PRUITTHEALTH TOWN CENTER

6300 Roberta Road
Harrisburg, North Carolina 28075

57 NEW PRIVATE BEDROOMS PLUS 2 NEW RENOVATED BEDROOMS

REVISED: 06-10-2016 PER EBI HUD REVIEW COMMENTS

1 PARTIAL FIRE ALARM FLOOR PLAN
1/8" = 1'-0"
PLAN NORTH

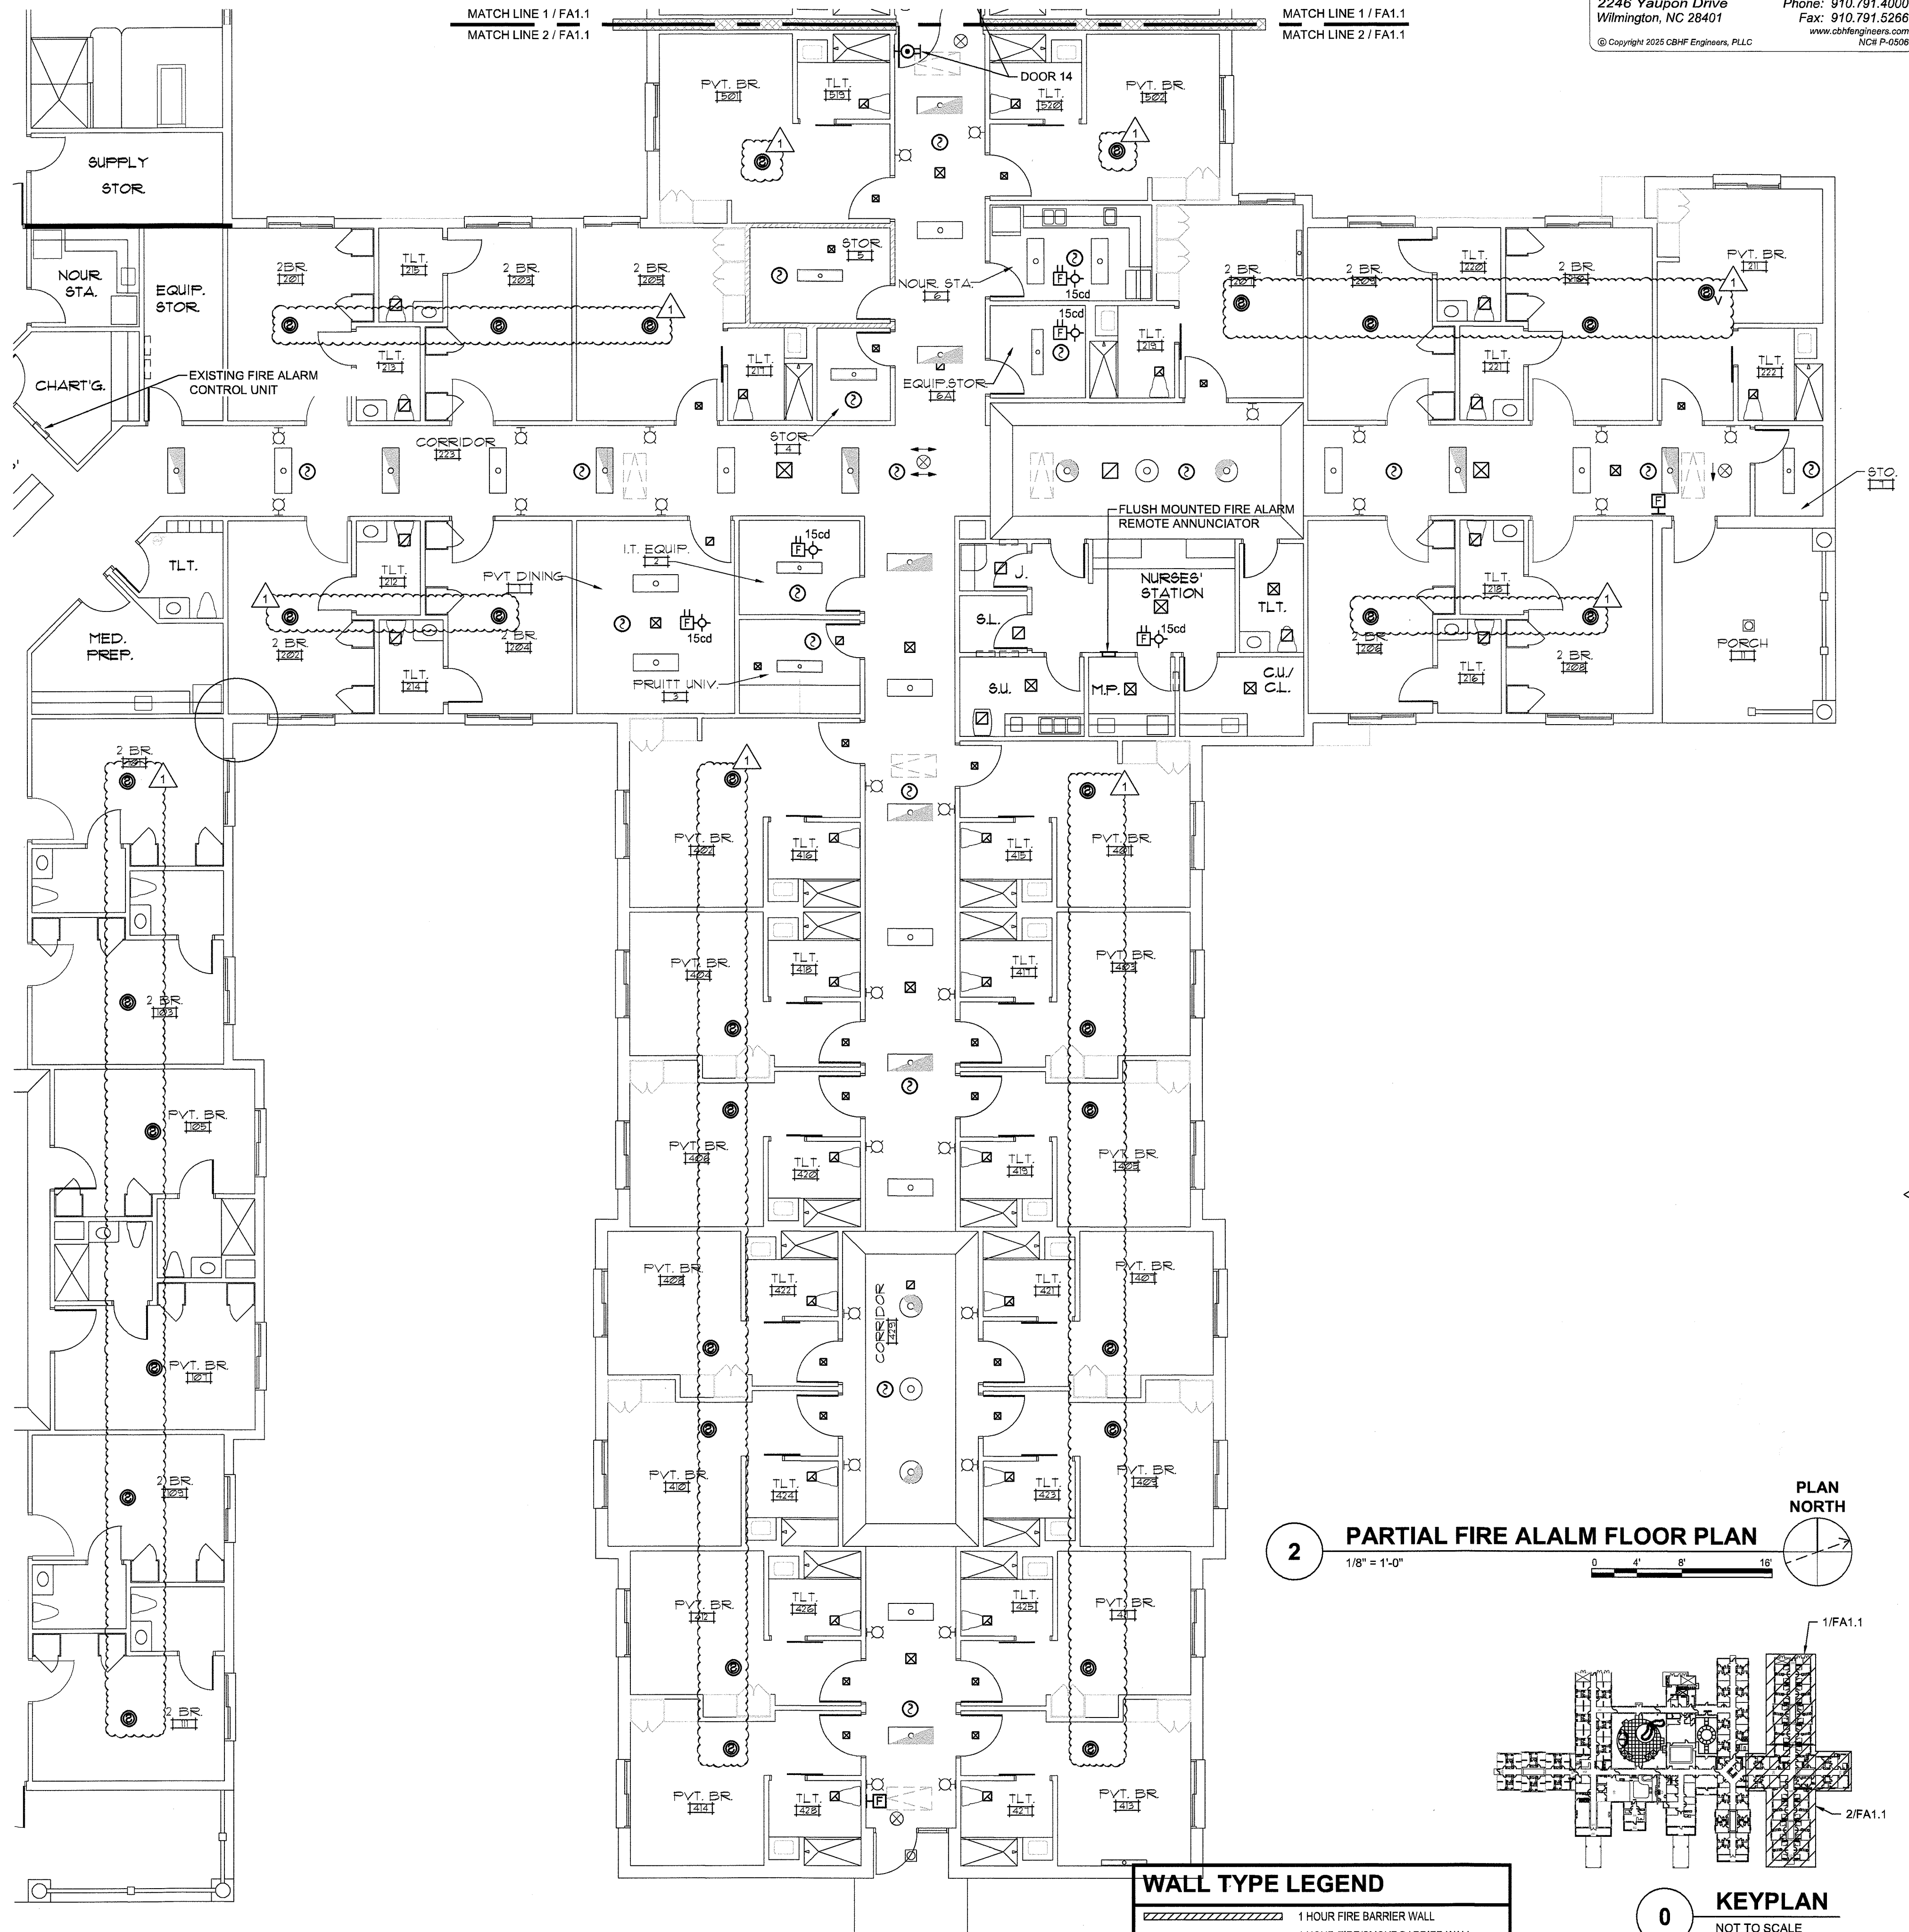
△ ADDED RESIDENT ROOM SMOKE ALARM

PARTIAL FIRE ALARM FLOOR PLAN
1/8" = 1'-0"

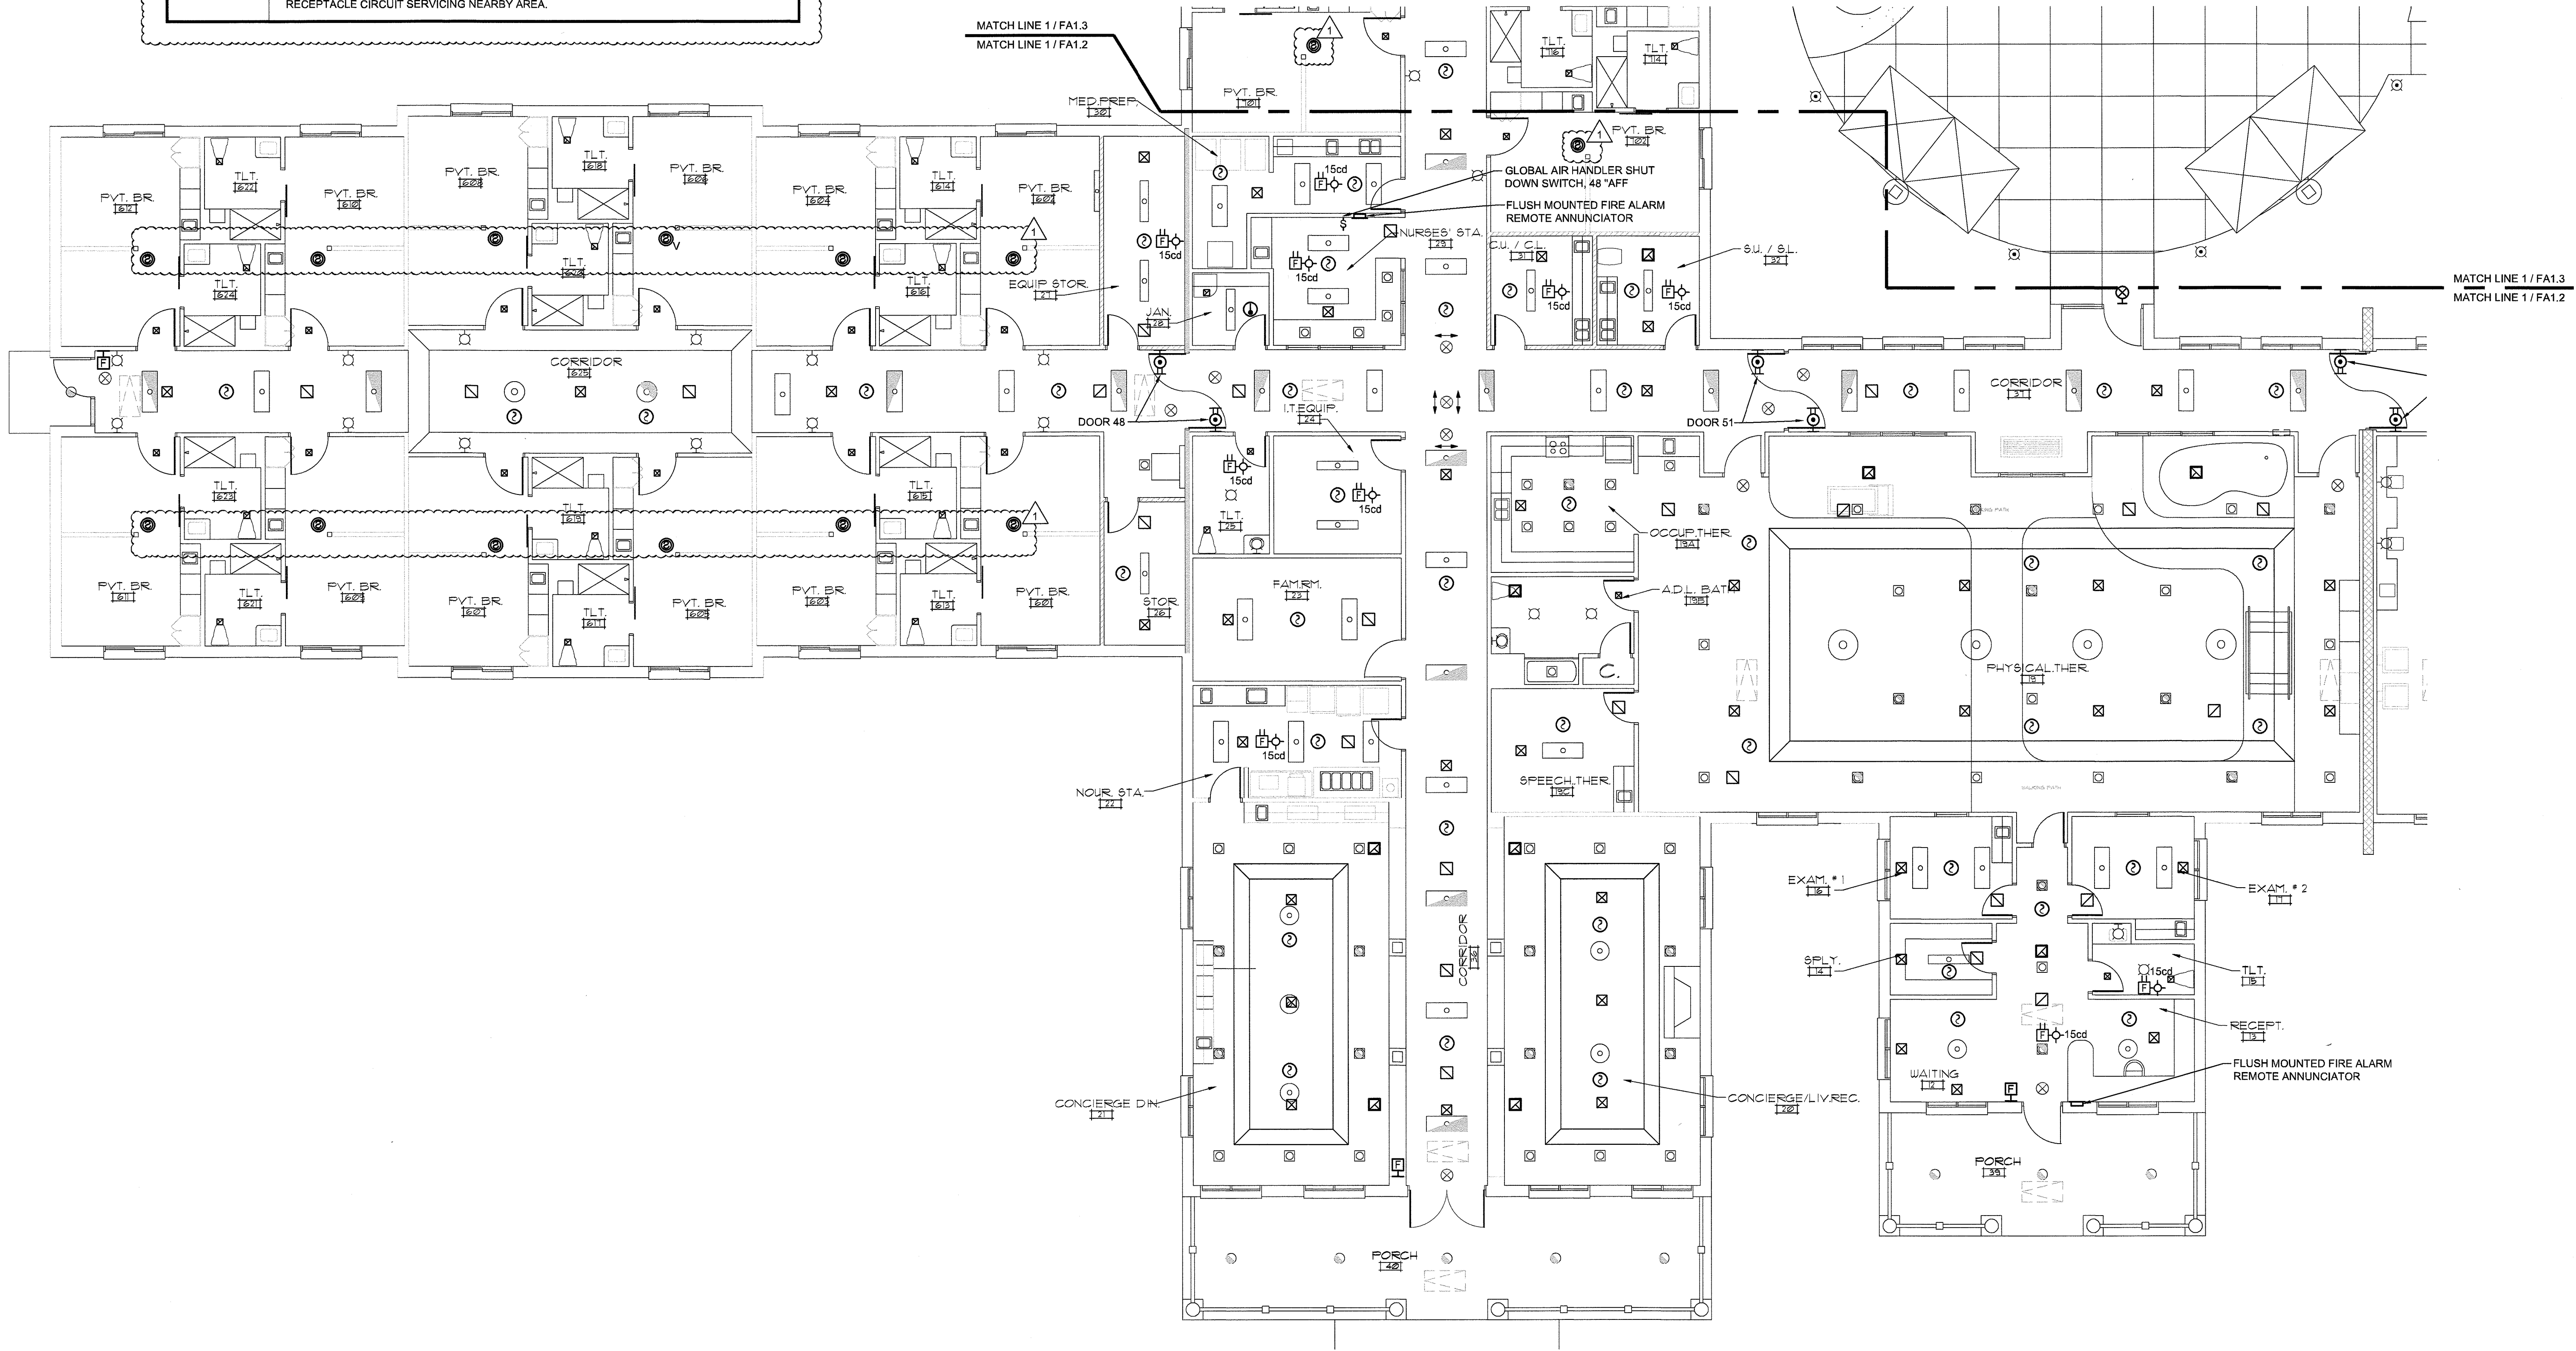
1. ADDED RESIDENT ROOM SMOKE ALARM

SYMBOL	DESCRIPTION
	PHOTOELECTRIC SMOKE ALARM, 120VAC HARDWIRED WITH 10 YEAR SEALED LITHIUM BATTERY BACKUP AND AUDIBLE ALARM, COMPLIANT WITH THE LATEST EDITIONS OF UL 217, UL 1730, IBC, AND NFPA 72, CEILING MOUNTED. POWER FROM NORMAL RECEPTACLE CIRCUIT SERVICING NEARBY AREA.
	PHOTOELECTRIC SMOKE ALARM, 120VAC HARDWIRED WITH 10 YEAR SEALED LITHIUM BATTERY BACKUP, AUDIBLE ALARM AND STROBE, COMPLIANT WITH THE LATEST EDITIONS OF UL 217, UL 1730, UL 1638, IBC, AND NFPA 72, CEILING MOUNTED. POWER FROM NORMAL RECEPTACLE CIRCUIT SERVICING NEARBY AREA.
